Bill No. 12-29

**TITLE:** **CHANGE OF ZONE NO. 05068B**, an amendment to **THE WOODLANDS AT YANKEE HILL PLANNED UNIT DEVELOPMENT**, requested by R.C. Krueger Development, on property generally located southeast of the intersection of South 70<sup>th</sup> Street and Yankee Hill Road.

## LINCOLN CITY/LANCASTER COUNTY PLANNING STAFF REPORT

- PROJECT #:** Annexation #11005  
**Change of Zone #05068B** - The Woodlands at Yankee Hill Planned Unit Development (PUD)
- PROPOSAL:** To annex approximately 35.39 acres of land and **change the zoning designation from AG to R-3 PUD** and to approve an additional 265,000 square feet of commercial floor area and 46 dwelling units.

UTILITY  
PLAN

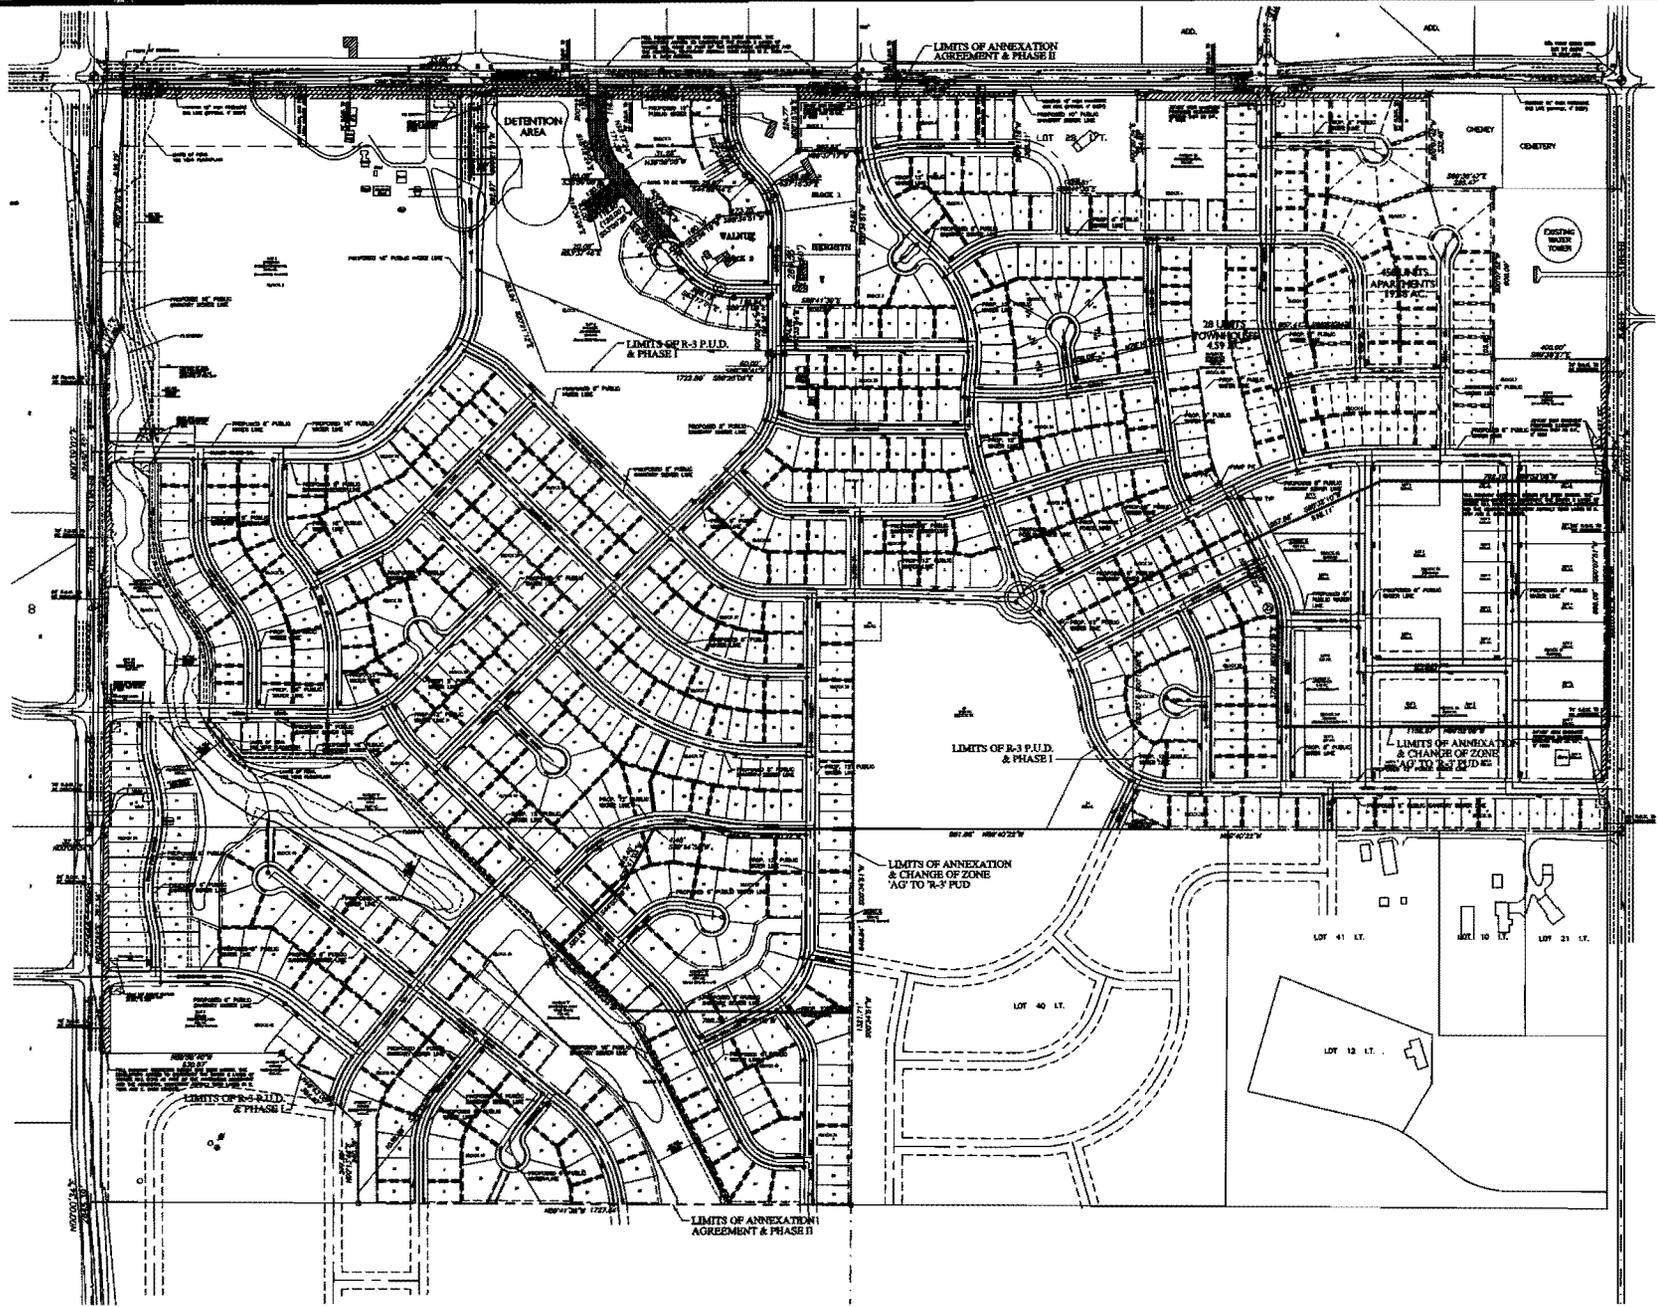
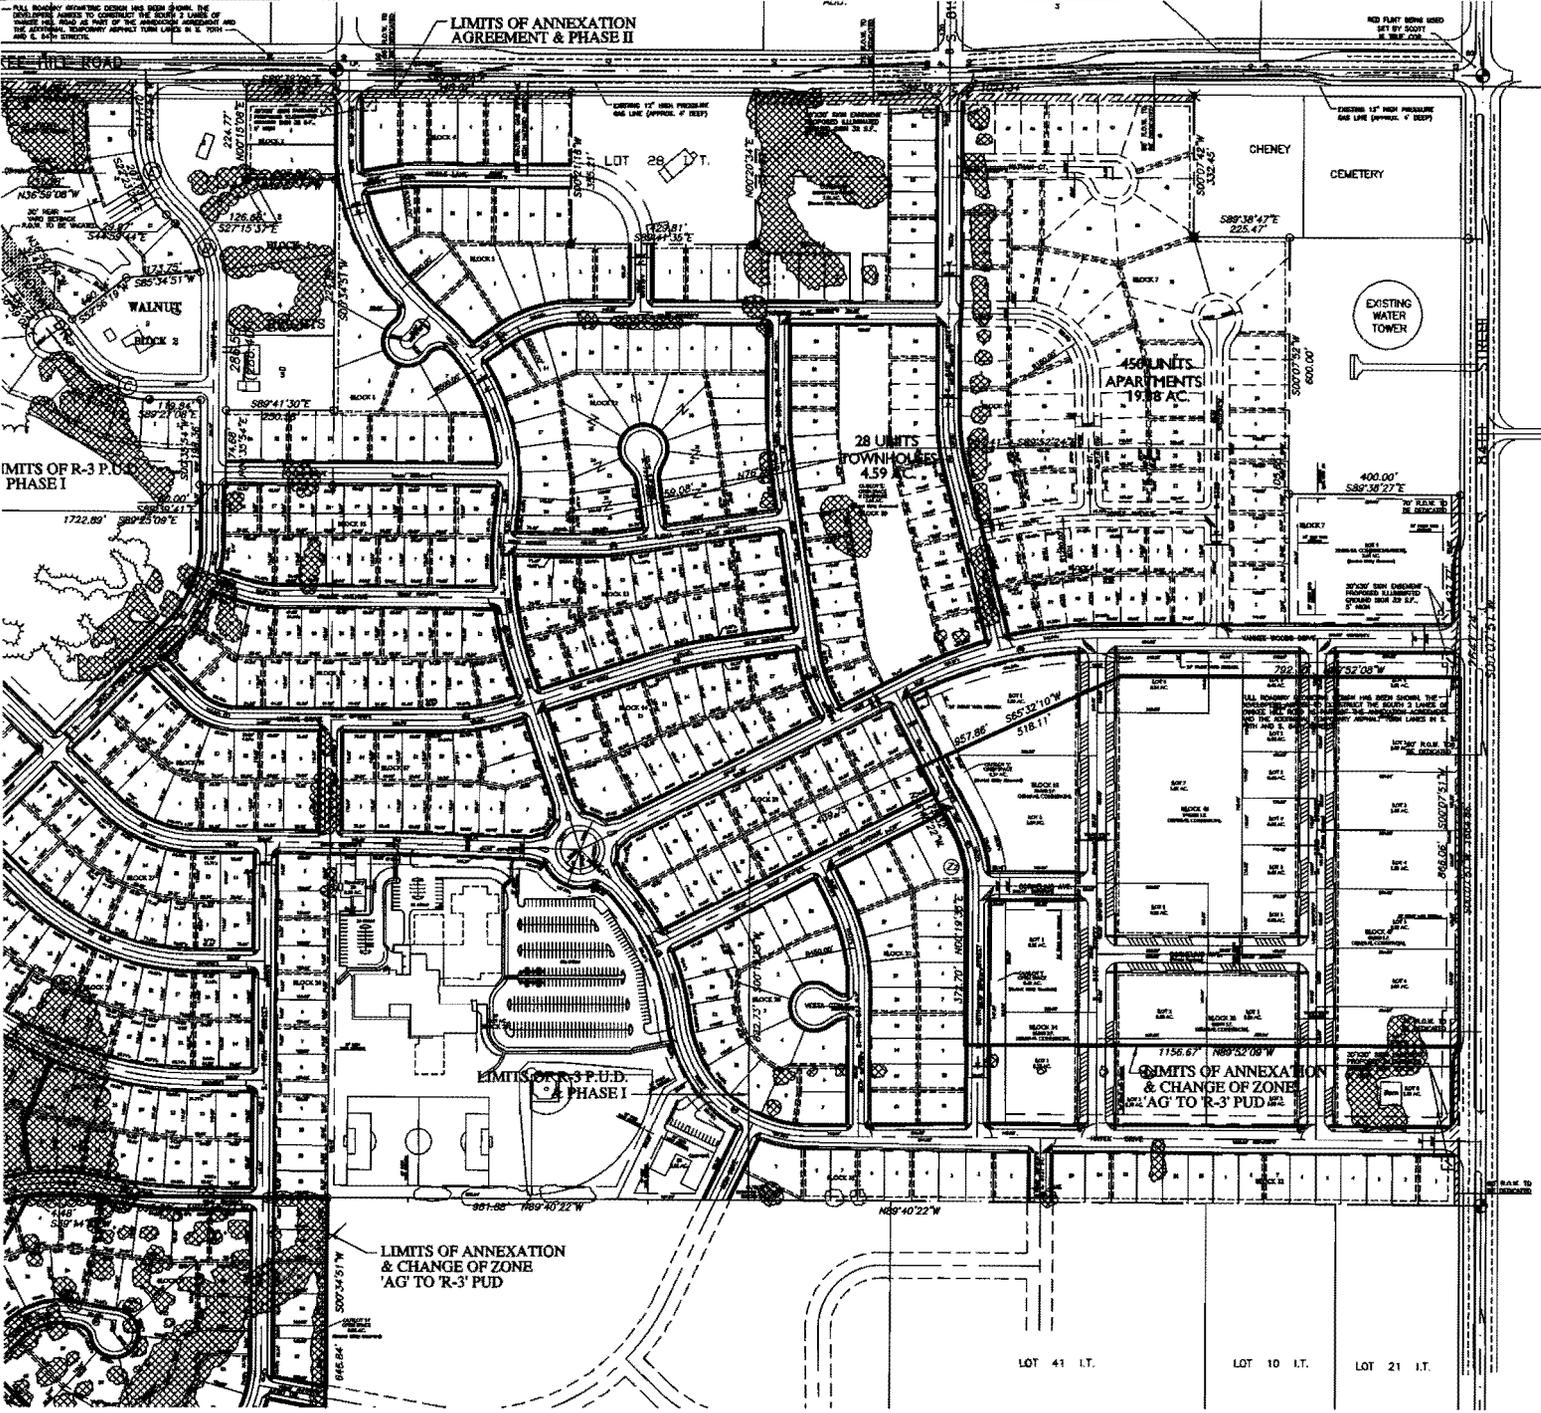
8. Public Works and Utilities noted several needed corrections and revisions to the utility and grading and drainage plans. The requirement to make those corrections and revisions to the satisfaction of Public Works and Utilities is noted as a recommended condition of approval.

<p>Review 1:</p>	
Public Works (Buff Baker)	<p> <input type="checkbox"/> Corrections Needed for Review    <input type="checkbox"/> Insufficient Information for Review  <input type="checkbox"/> Recommend Denial    <input checked="" type="checkbox"/> Recommend Approval with Conditions    <input type="checkbox"/> Recommend Approval    <input type="checkbox"/> No Review Required         </p> <p>Review 1: See Dennis' comments</p>	
Public Works (Dennis Bartels)	<p> <input type="checkbox"/> Corrections Needed for Review    <input type="checkbox"/> Insufficient Information for Review  <input type="checkbox"/> Recommend Denial    <input checked="" type="checkbox"/> Recommend Approval with Conditions    <input type="checkbox"/> Recommend Approval    <input type="checkbox"/> No Review Required         </p> <p>Review 1: The plans need to be revised and corrected:</p> <p>██████████ standards require storm sewer in commercial areas to be designed to handle a 10 year design storm, a 5 year storm was used in the calculations. A 0.6 runoff coefficient was used to calculate runoff in the commercial areas. With the zero setbacks and parking bays along the private roadways requested, I recommend a minimum 0.7 coefficient if not higher.</p> <p>A graded swale for overland flow is needed in the outlot east of 80th where the storm sewer is shown to drain to the open ditch. The plans show the 80th Street frontage of this outlot draining back to 80th rather than toward the open ditch. The grading of the detention outlot north of Patrick Avenue needs to be revised to show the outlet storm sewer having grading matching the flowlines shown on the plans and calculations. The volume of the detention shown needs to be checked. It appears from my review of the detention study and my assumptions concerning the grading plan that the calculated volumes are not provided. Part of the detention per existing grades will pond on the property to the south outside this development. Sufficient storage is needed in this PUD to provide the required detention in the event the property outside this PUD is raised.</p> <p>Rear lot drainage is proposed to provide the interior block drainage in Blocks 8 and 14. Rear lot drainage is undesirable for the distances shown because of the potential drainage problems that can be created for the individual lot owners and no effective way for an individual owner to protect himself or remedy problems. It is especially problematic in Block 14 where the surface drainage must angle across the buildable area of Lot 1 to reach 80th Street.</p> <p>City records show that a storm exists across 84th Street near the north lin of Lot 1, Block 7. This drainage across 84th Street is not accounted for in the drainage study. The surface drainage across Lot 1 outletting into the rear yard of potential residential lots is not acceptable whether or not this storm sewer still exists.</p> <p>The grading along 84th Street is shown blending into existing contours along the ROW line. Aerial contours show that the property at the ROW line in places is considerably lower than existing 84th paving. This application should include submittal of preliminary street grades for a future 4 lane paving of 84th and the grading revised to show how the interim and final grading will be accomplished when 84th is graded and paved.</p> <p>2. Water- The site plan does not accurately show the size of the water mains recently built in future 80th Street and in Yankee Woods Drive.</p> <p>3. Sanitary sewer- The sanitary sewer easement location shown across the detention cell in Block 6 is unsatisfactory. The location is shown at the low point of the detention through an existing wetland.</p> <p>██████████ should be revised</p>

1.2 Submit revised grading, drainage, and utility plans to the satisfaction of Public Works and Utilities.
